Proposed Modifications to 1000BASE-T1 State Diagrams and Variables

May 18, 2015

Peiqing Wang and Mike Tu

Changes to Figure 97-2

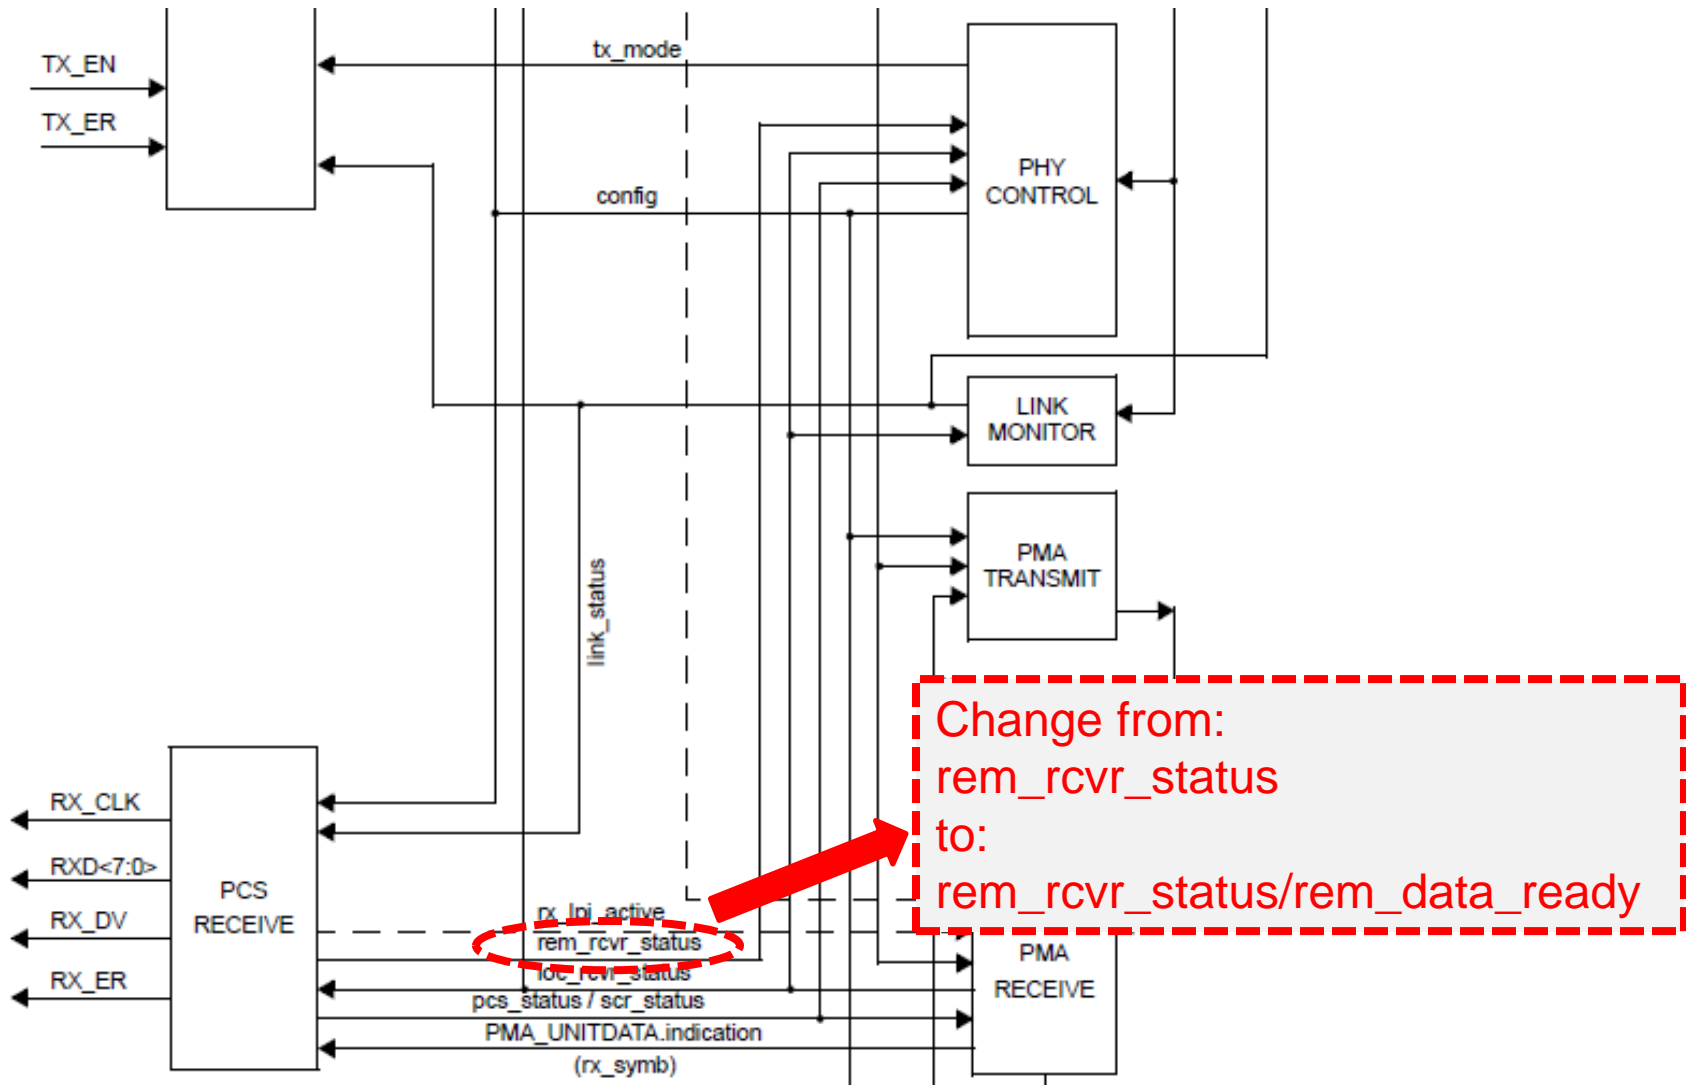
Change from:
rem_rcvr_status
to:
rem_rcvr_status/rem_data_ready

Figure 97-4—PCS reference diagram

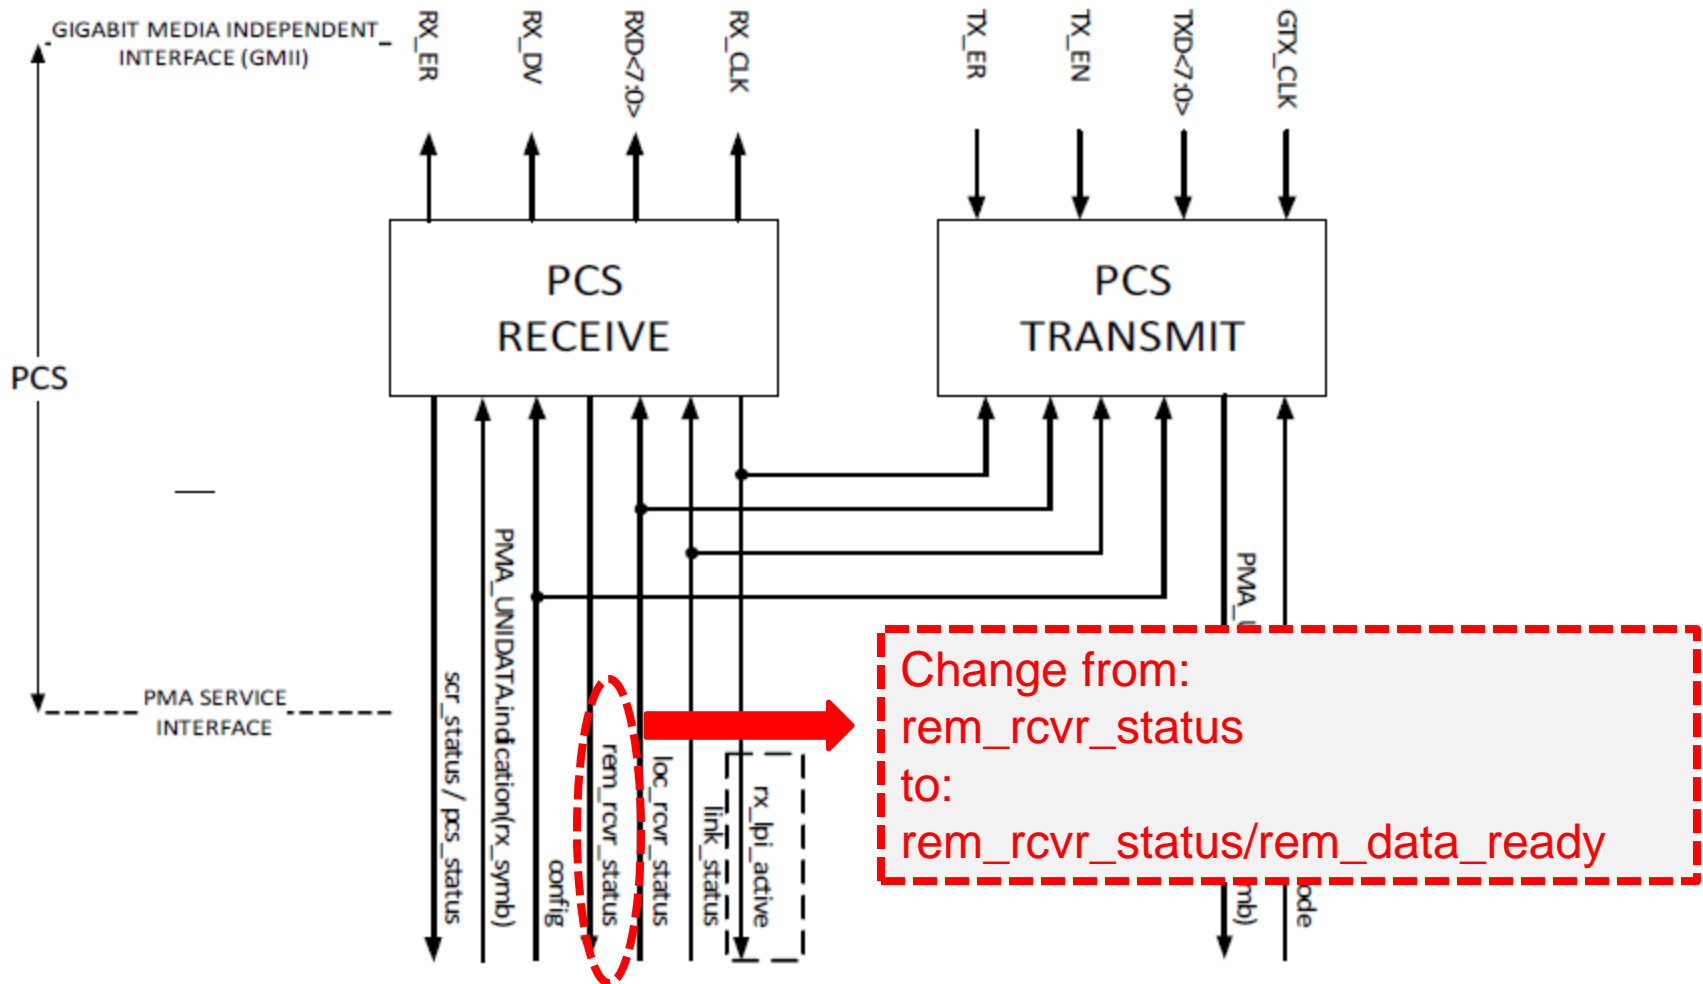
Changes to Figure 97-4

Figure 97-16—PMA reference diagram

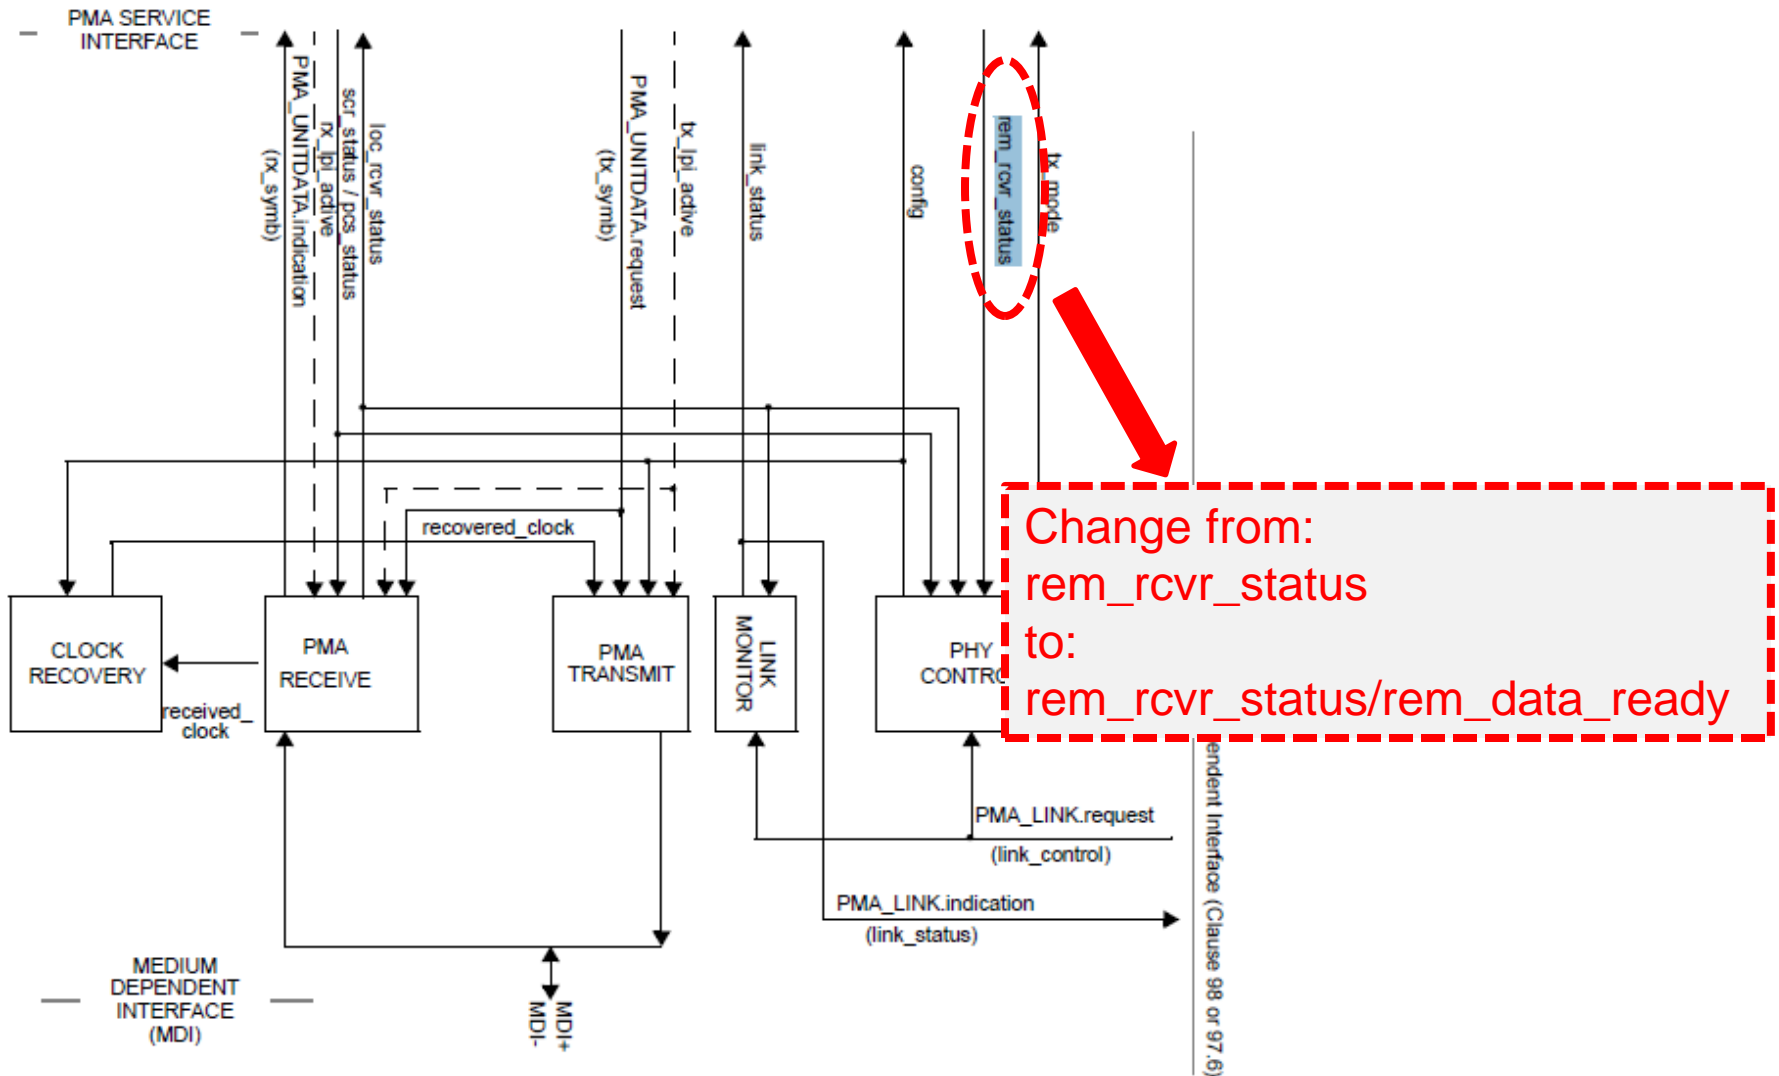
Changes to Figure 97-16
